# **Response-to-Comments Document**

**February 2002 Peer-Review Draft of the  
American River PHABSIM/2-D Flow Study Report**

**February 2003**

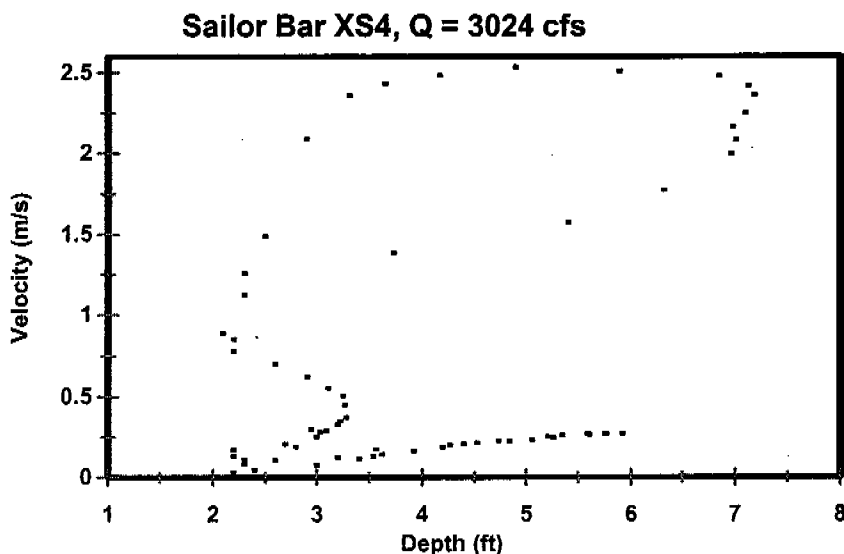
**Comment 3:** 2D vel proportional to depth? Inflow @ outflow boundary forces this distribution @ XS1? Extend site use BC5 & calibrate. (Page 32, Sailor Bar XS4 figure)

**Response:** We assume that the commenter meant XS4 instead of XS1. As shown in the graph below, the velocities simulated by the 2-D model do not appear to be proportional to the measured depths. Since the inflow at the outflow boundary only propagates 30 m upstream of the outflow boundary, it

does not appear that the inflow at the outflow boundary forces this distribution at XS4. Accordingly, we do not feel that it is necessary to extend the site downstream, use boundary condition 5 and recalibrate. In any case, time and manpower constraints make it impossible for us to recalibrate and rerun the Sailor Bar site model. As discussed in the report, we attribute the simulated velocity pattern at XS4 to the effect of the velocity distribution at the upstream boundary.

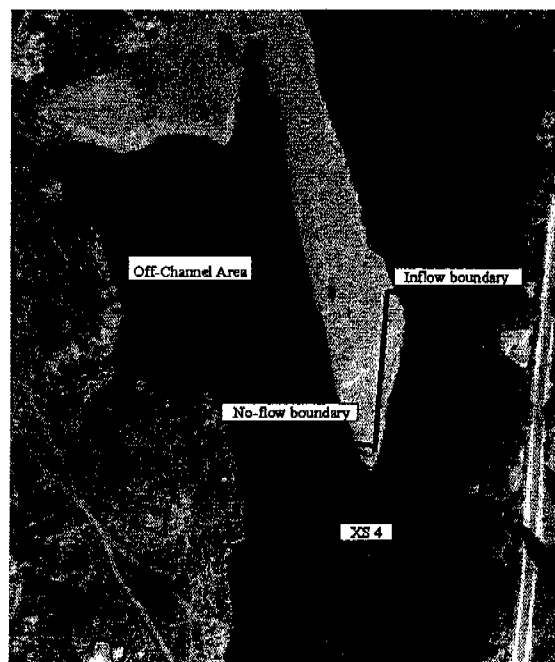
**Comment 4:** Sailor inflow at outflow boundary affects last 100 m velocity distribution, maybe more. Right Bank groove picks up too much Q. Inflow notched topography means invalid until distributes about 2 widths from notch. What's really going on? Rerun with full width inflow extended and outflow extended to remove distribution problems and outflow boundary errors. (Page 33)

**Response:** At the validation velocity flow for XS1 (3,042 cfs), the inflow at the outflow boundary only affects the last 30 m of the velocity distribution. Even at higher flows (10,287 cfs), the inflow at the outflow boundary only affects the last 50 m of the velocity distribution. Only the simulated velocities 35 m upstream of the inflow at the outflow boundary (shown in Sailor Bar Deep Beds A in the final report) and at XS1 differ substantially from the measured velocities due to the inflow at the outflow boundary. The effect of the inflow at the outflow boundary does not appear to affect the velocities 100 m upstream of the outflow boundary (shown in Sailor Bar Deep Beds B in the final report). We agree that the right bank groove does pick up too much flow - we attribute this to the velocity distribution at the upstream boundary. The notched topography at the inflow boundary represents the real configuration of the river channel upstream of the Sailor Bar site - the notched area is an entrance to an off-channel area (as shown in the aerial photo below), with a resulting major expansion of the river channel at this location. Time and manpower constraints make it impossible for us to modify and rerun the Sailor Bar site model.

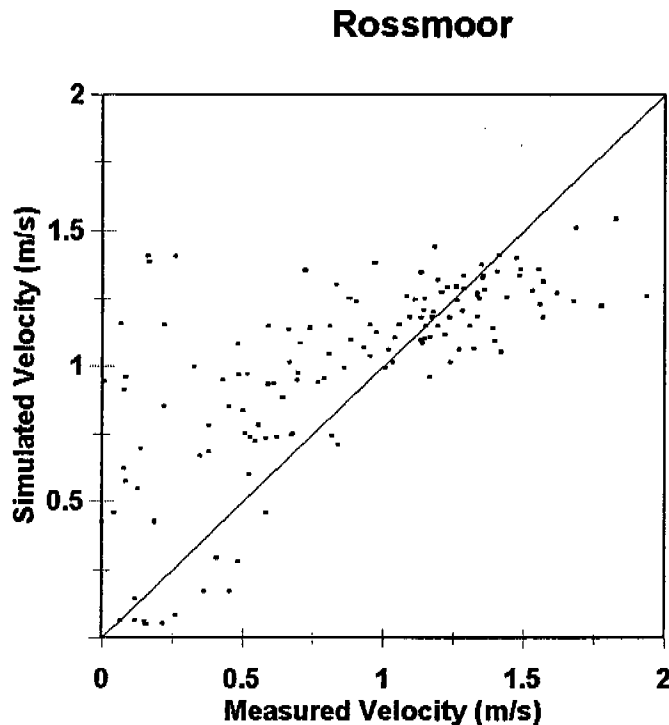
**Comment 15:** How about for Xsecs where  $Q$  matches? (Page 60, lower right-hand graph)

**Response:** The graph below shows measured versus simulated velocities for the ten deep bed runs at Rossmoor where Mode 8 (which would be expected to give more accurate velocities) was used (Deep Beds H through Q in the final report). There does appear to be a better correlation between measured and simulated data when only Mode 8 data are examined.
